## CITY OF TONTITOWN PLANNING OFFICE

Meeting: **February 26, 2019**  
Project: **Ttown 112 Apartments**  
Planner: Courtney McNair

### PRELIMINARY LARGE SCALE DEVELOPMENT PLAN APPROVAL REQUEST

**SUMMARY:** TTown 112 Apartments is requesting Preliminary Large Scale Development (LSD) approval for 11-24 unit apartment buildings to be constructed in two phases on 21.56 acres for a total of 264 units.

OVERALL LAYOUT  
TTOWN 112 APARTMENTS  
TONTITOWN, ARKANSAS

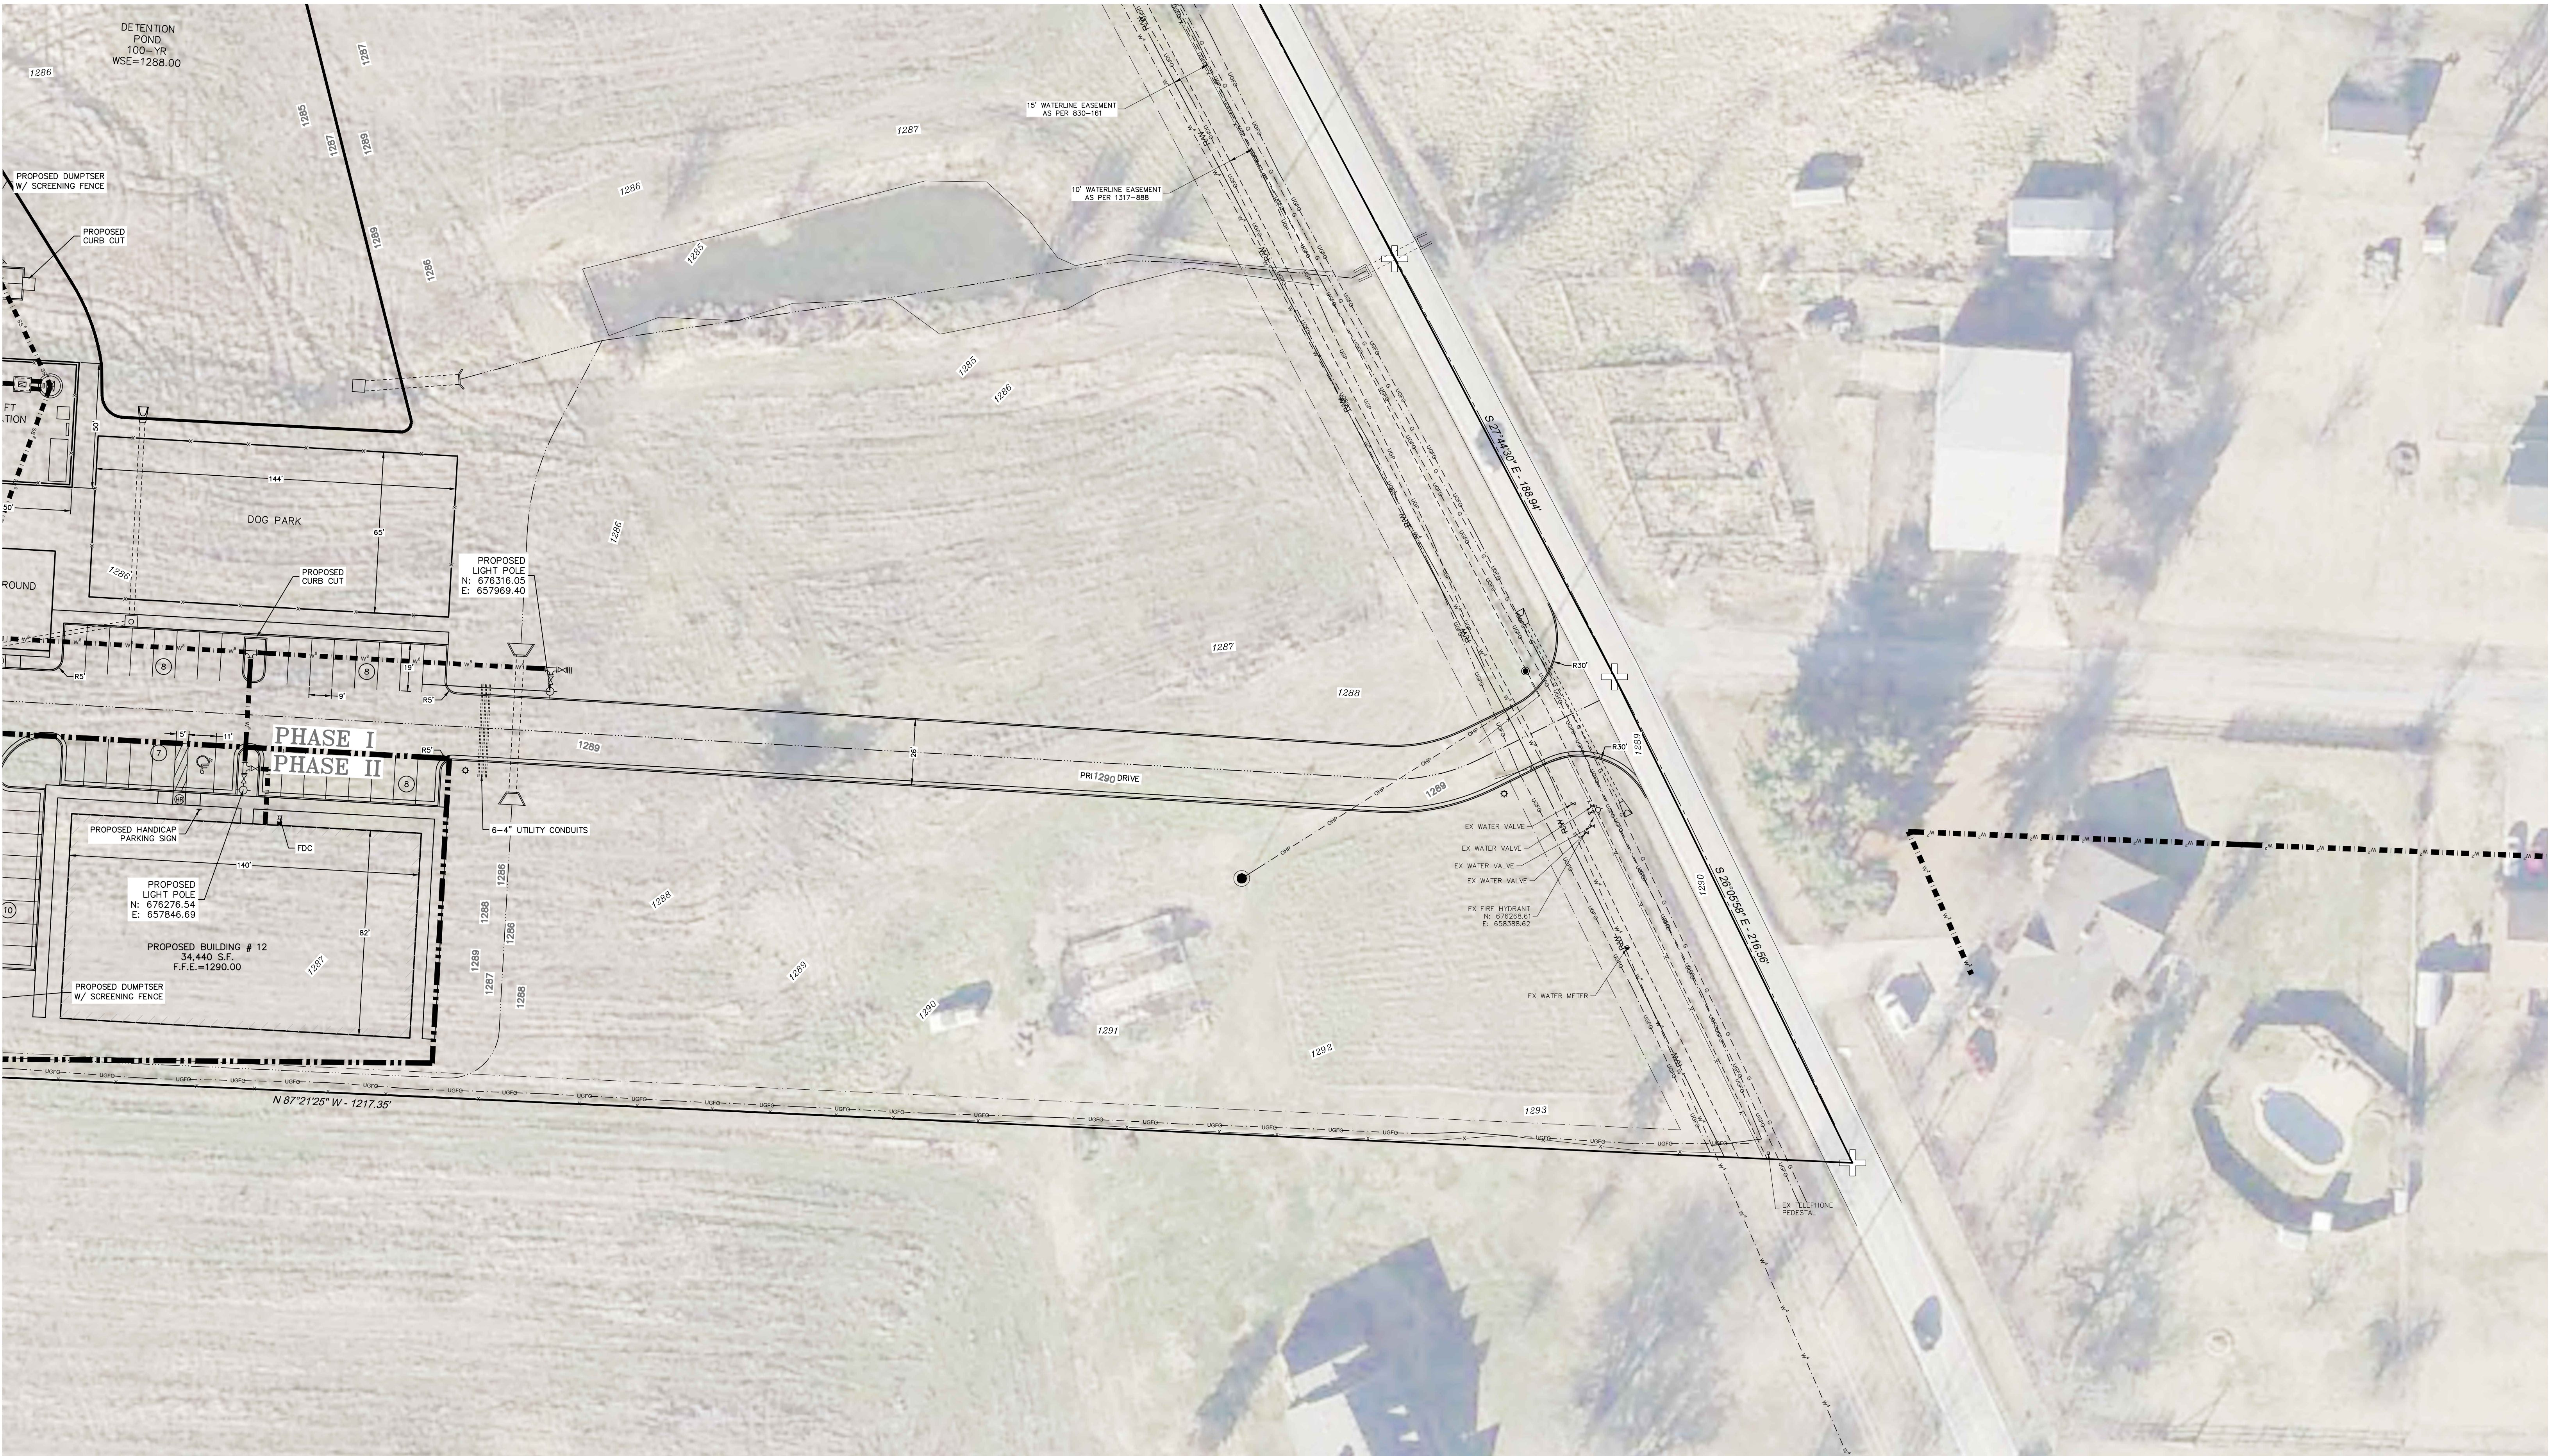
Site visibility appears to be adequate from the proposed entrance location. Staff has requested that the alignment of nearby drives be shown on the plans to provide an overall view of the connections onto S. Maestri in this area.

The applicant is requesting a waiver from the sidewalk requirements along S. Maestri Road as ARDOT (Arkansas Department of Transportation) is proposing to improve this street and the street plans are not finalized. WAIVER-SIDEWALKS

Sidewalks to connect from the interior along the entrance drives, to S. Maestri Road must be added to the plans.

**STAFF RECOMMENDATION:** Staff recommends DENIAL of the waiver request to remove the sidewalk requirement along S. Maestri Road.
